ADDENDUM NO. 2

Issued by: Sacramento City Unified School District

Project: Project #: 0029-401 Bret Harte Playground

A0.1

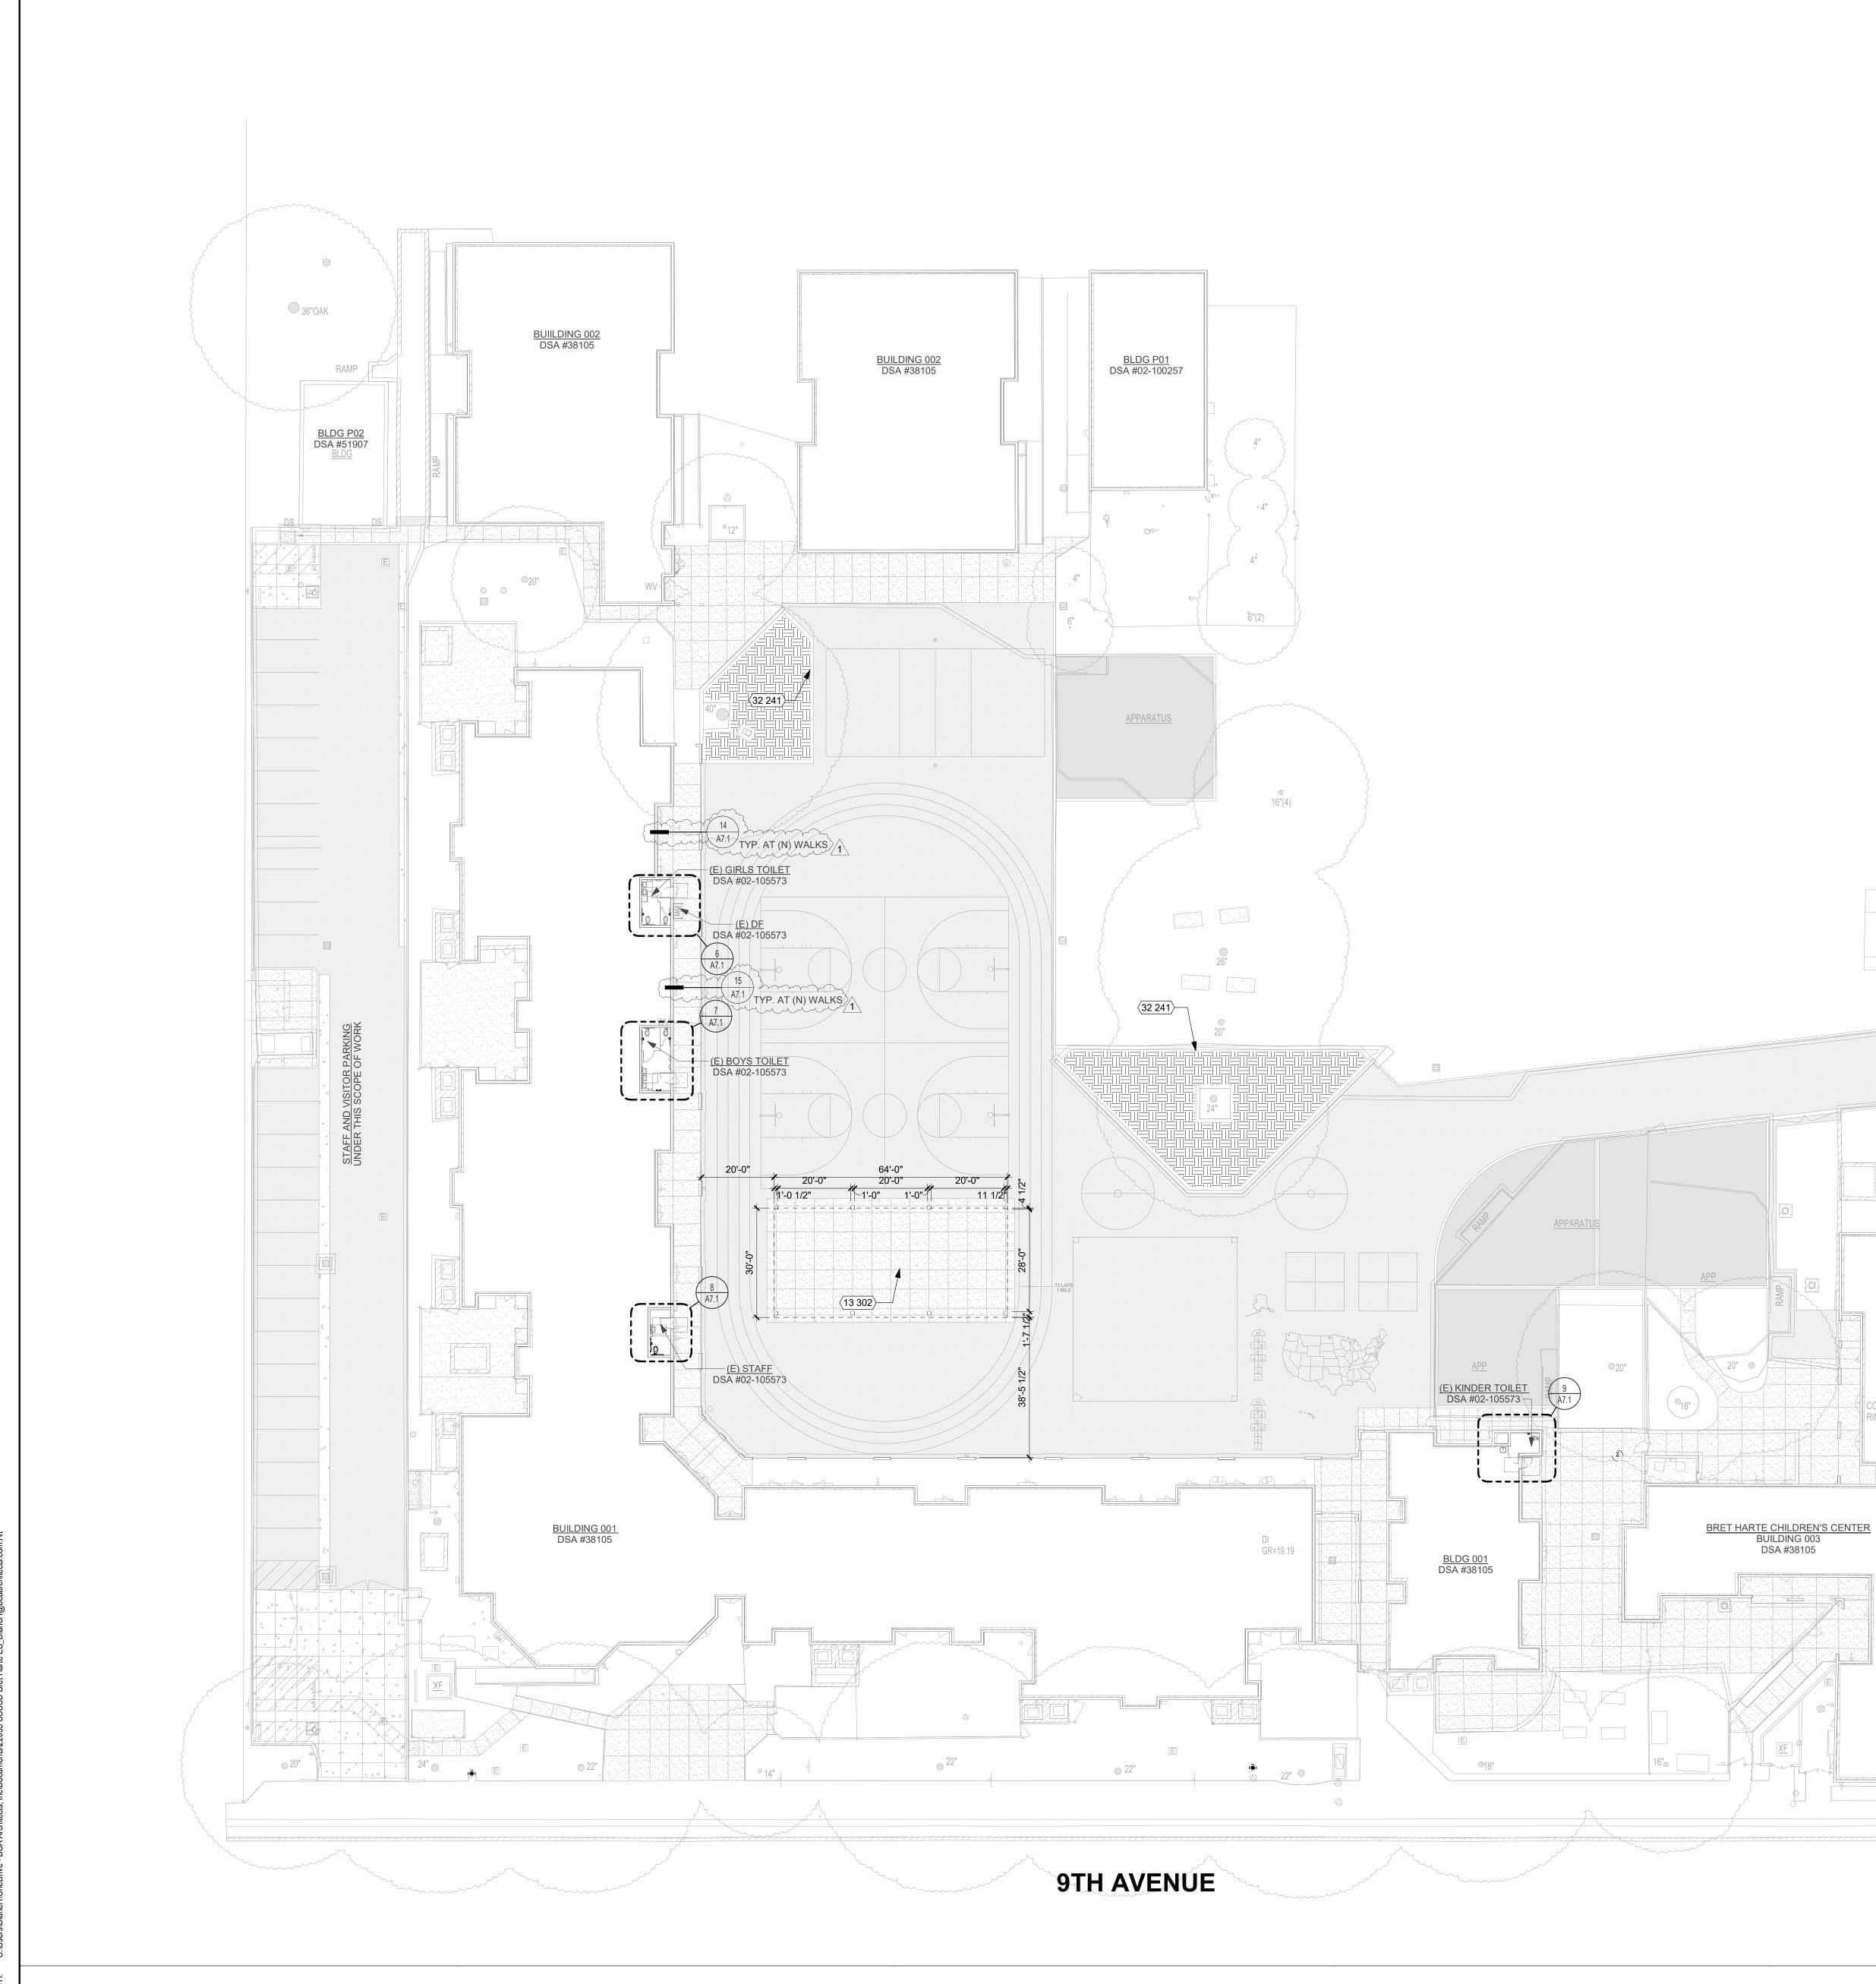
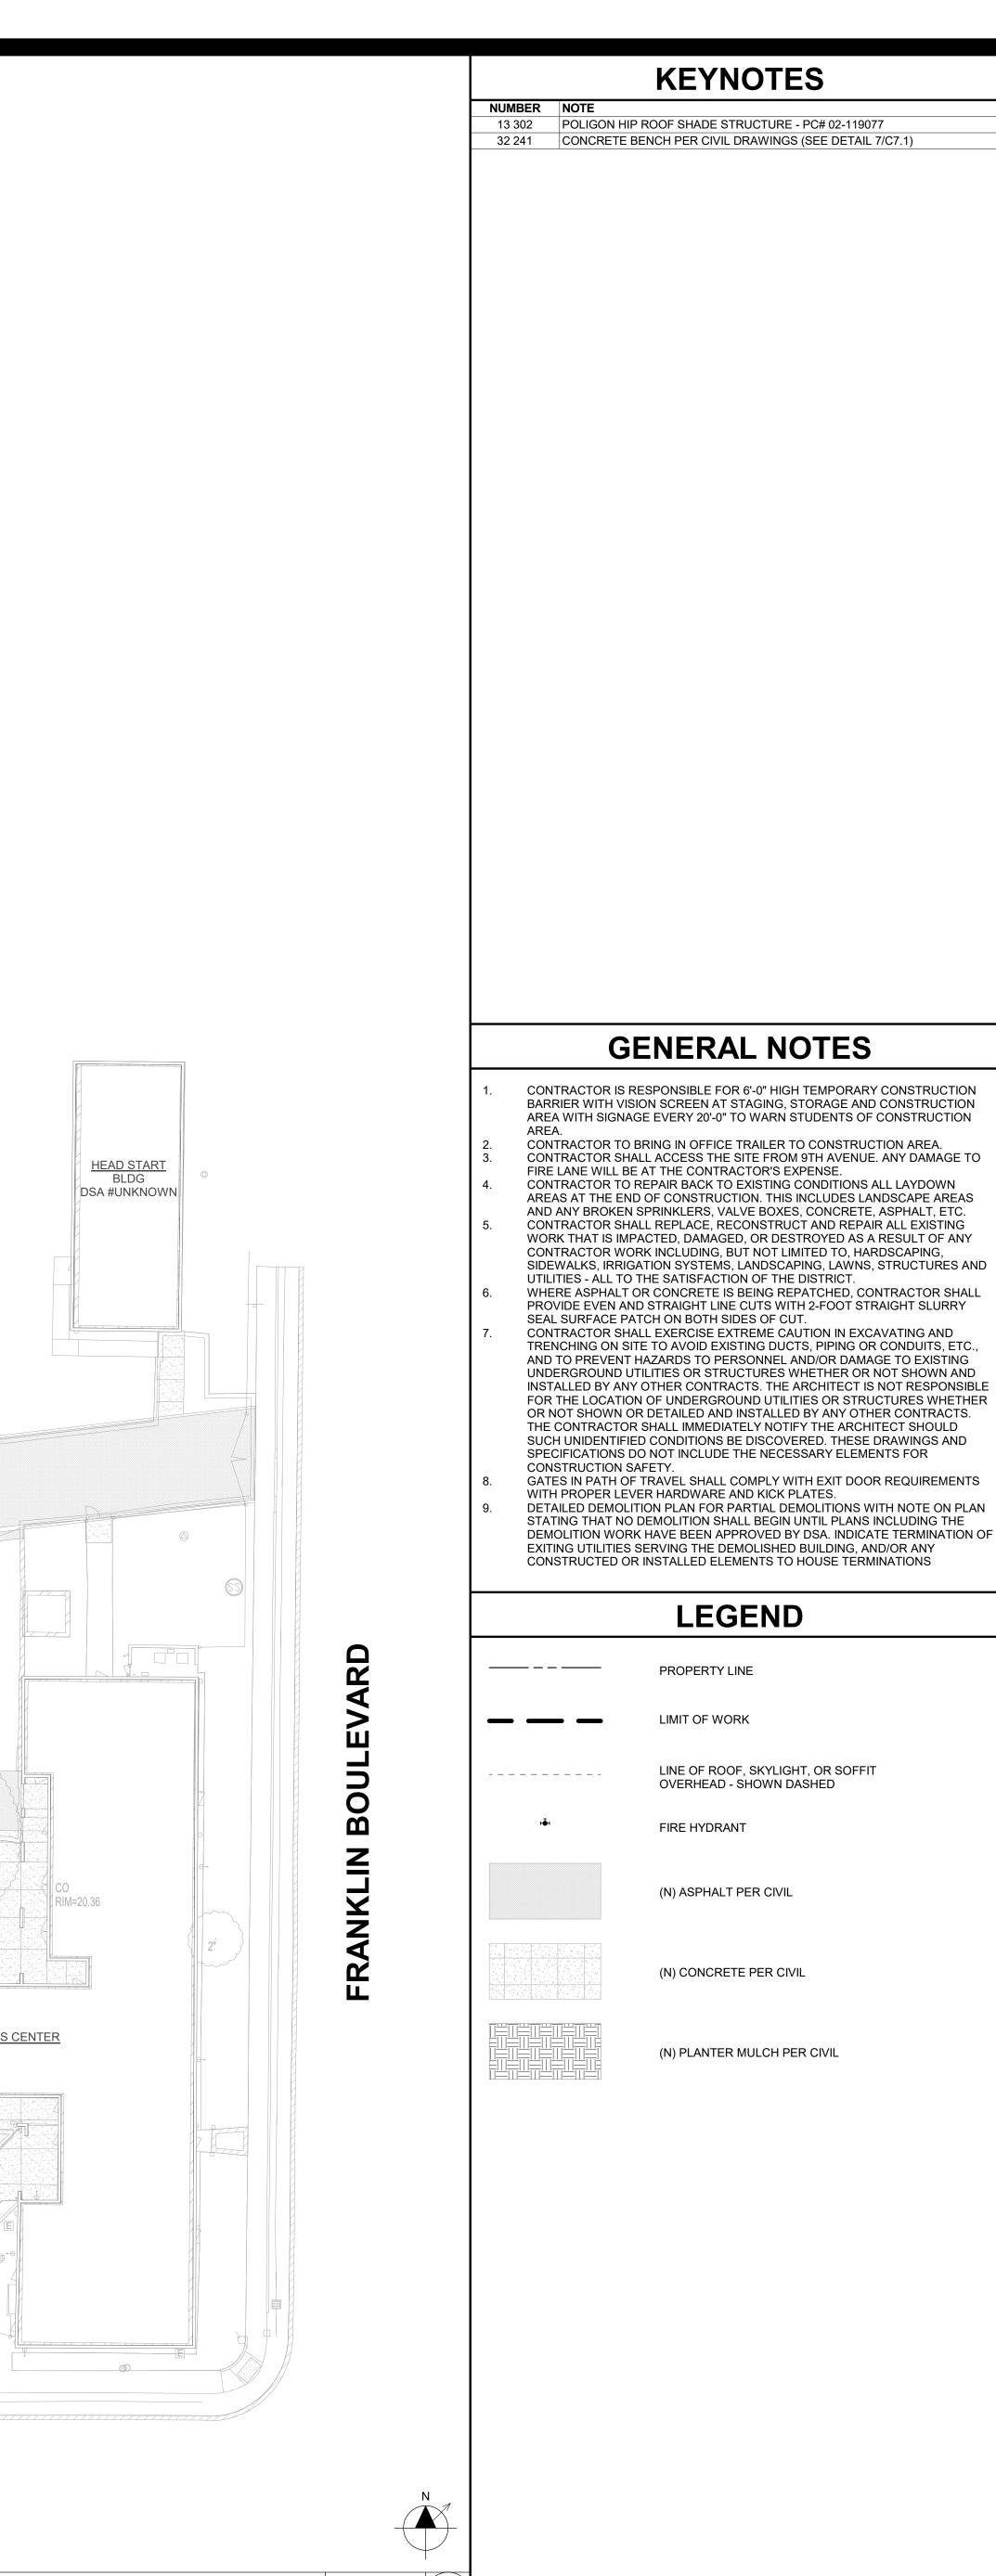
- B. SHEET A0.1:
 - Add Alternates is now Base Bid: 64'-0" X 30'-0" Shade Structure – Poligon – PC# 02-119075. OFCI, Contractor to coordinate delivery, offloading, storage and installation
- C. SHEET A1.1:
 - 1. Details 14/A7.1 and 15/A7.1 have been added to wall and doors

| DSA STAMP | | |
|---|--|--|
| 01/24/2023 22035 Scale Drawin AS SHOWN | t Number og Number C1.1 | |

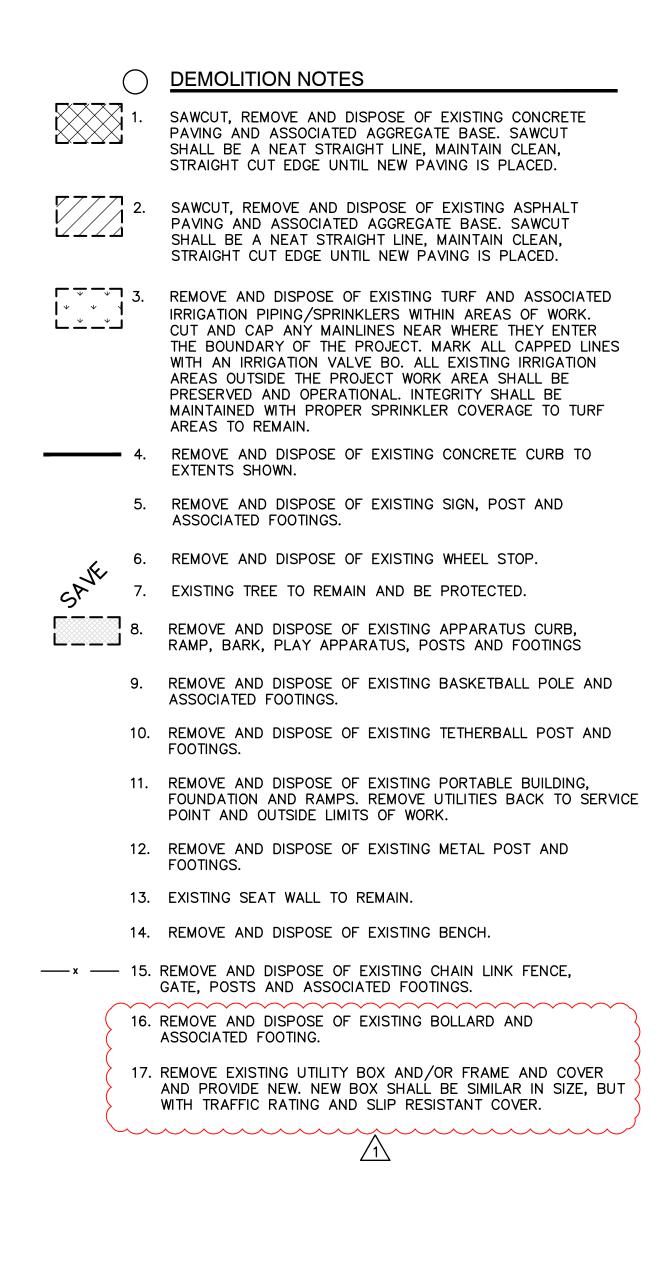
- D. SHEET C1.1:
 - 1. Add note 15 to demolished gate off of Franklin Blvd
 - 2. Add additional demolition to area adjacent to shed
 - 3. Add removal of bollards at parking area

- 4. Add notes 16 and 17 to Demolition Notes
- E. SHEET C1.3:
 - 1. Add additional site clearing to area adjacent to shed
- F. SHEET C2.1:
 - 1. Revision to note 10 under Grading Notes

| DSA STAMP | | |
|---|--|--|
| GRADING PLAN | | |

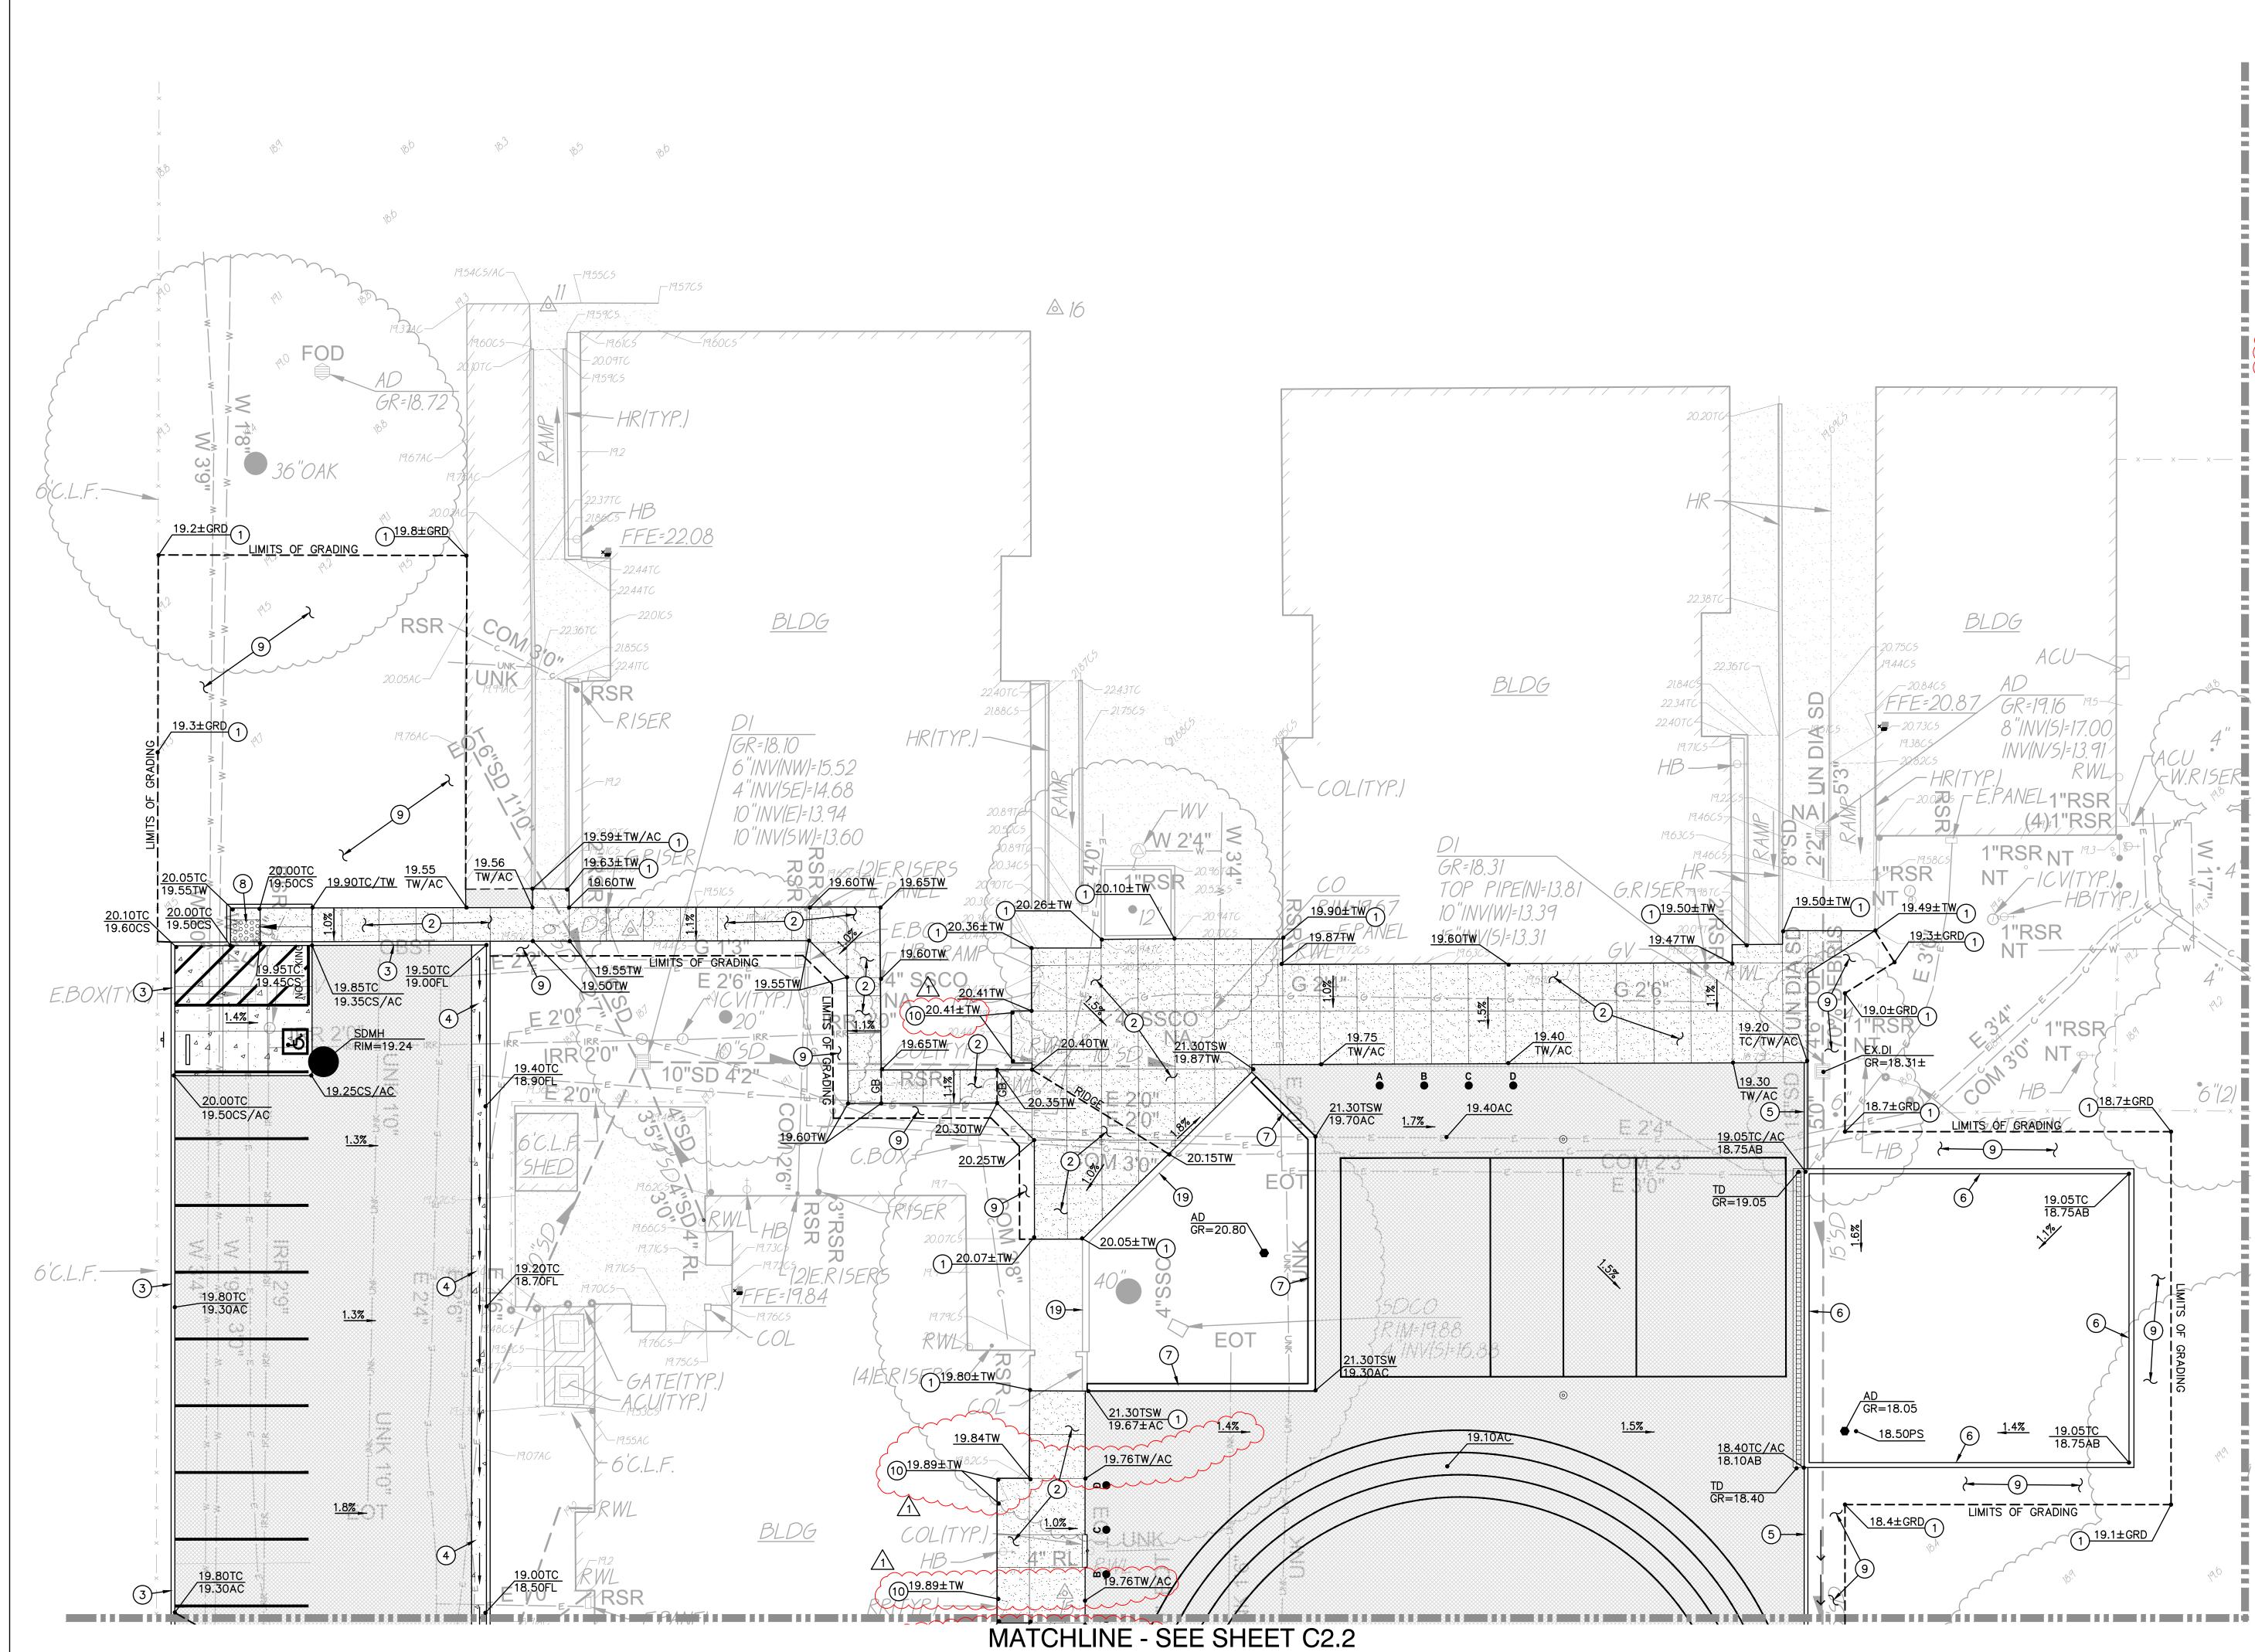
- 2. Grading elevation revisions at Building 001
- G. SHEET C2.2:
 - 1. Add chain-link fence and gate to new enclosure in new parking lot
 - 2. Grading elevation revisions at east side of Building 001
